REMARKSDrawings

Serial No. 10/022,002

FIG-2C

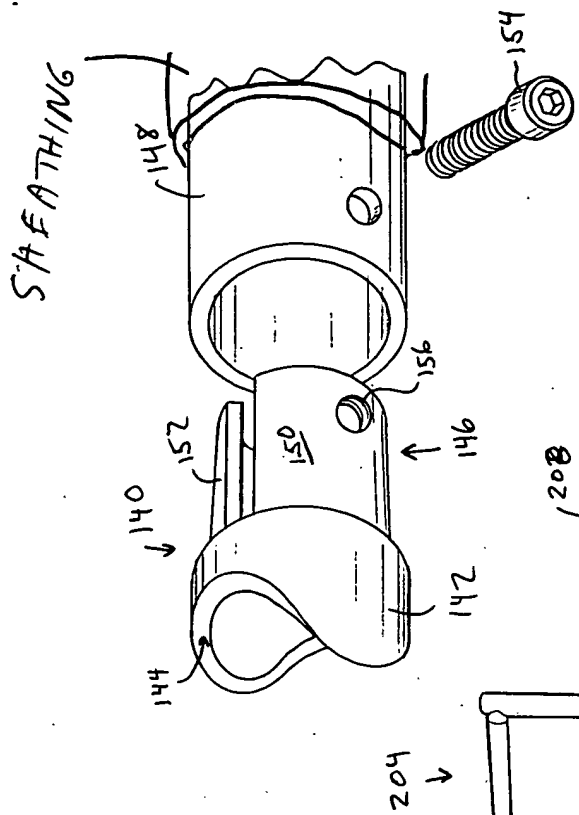
With regard to (c), Figure 2C has been amended, though Applicant feels such an amendment is entirely unnecessary.

FIG-3

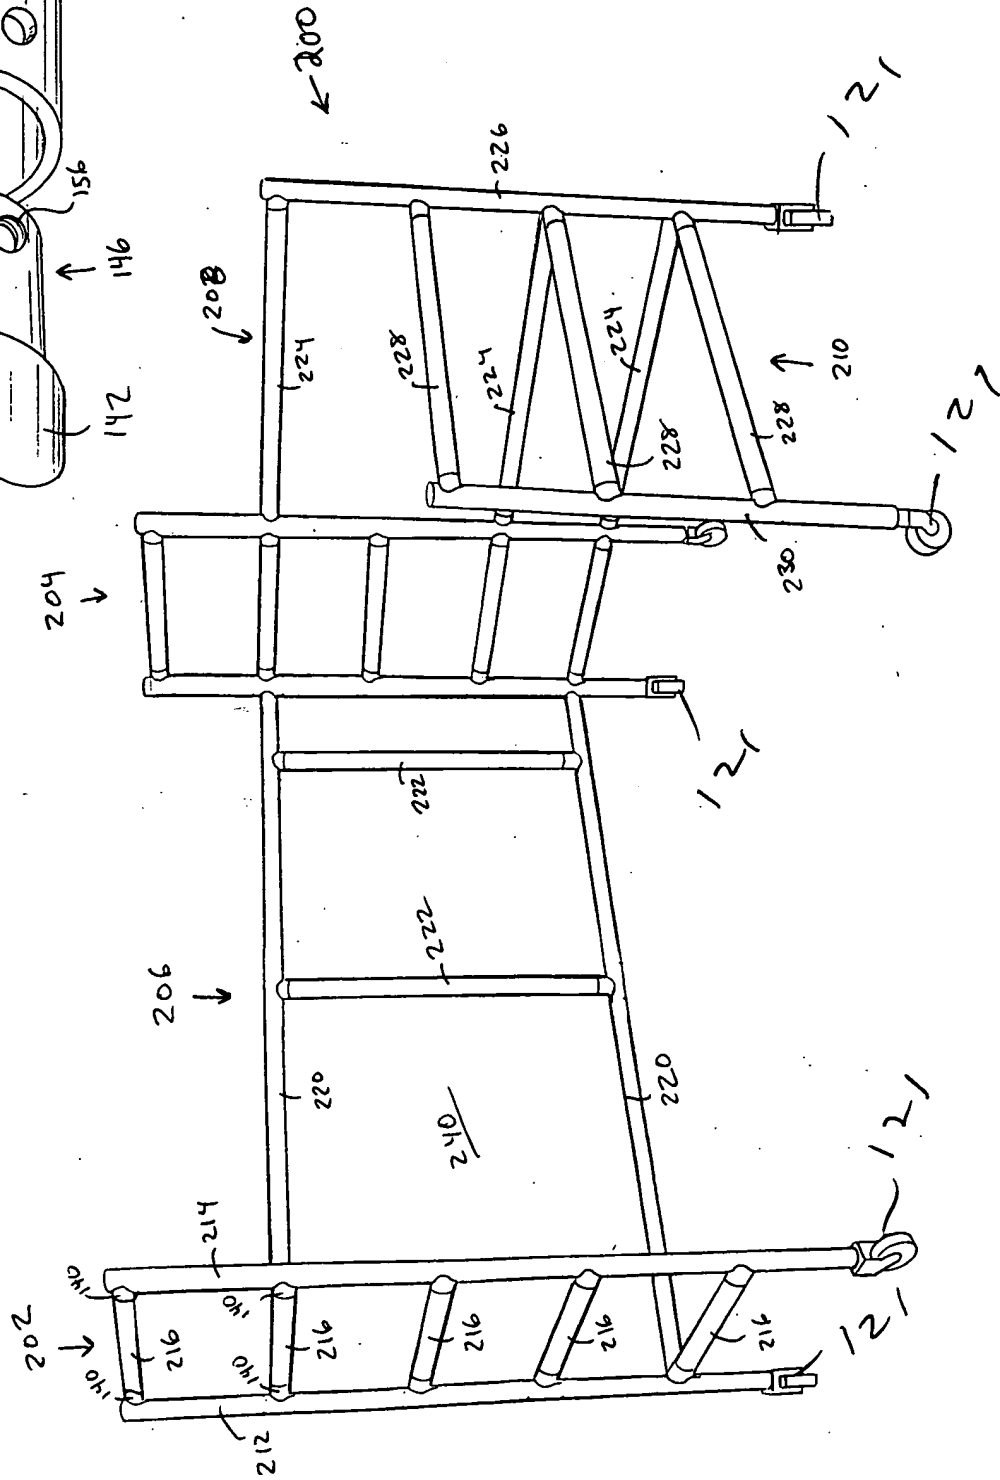
With regard to (b) on page 3, Applicant cannot comprehend why it would be necessary to show the fittings of Figures 2A and 2B in Figures 1, 3 or 4. In fact, Figures 1, 3 and 4 utilize an alternative fitting (i.e., 112, 140).
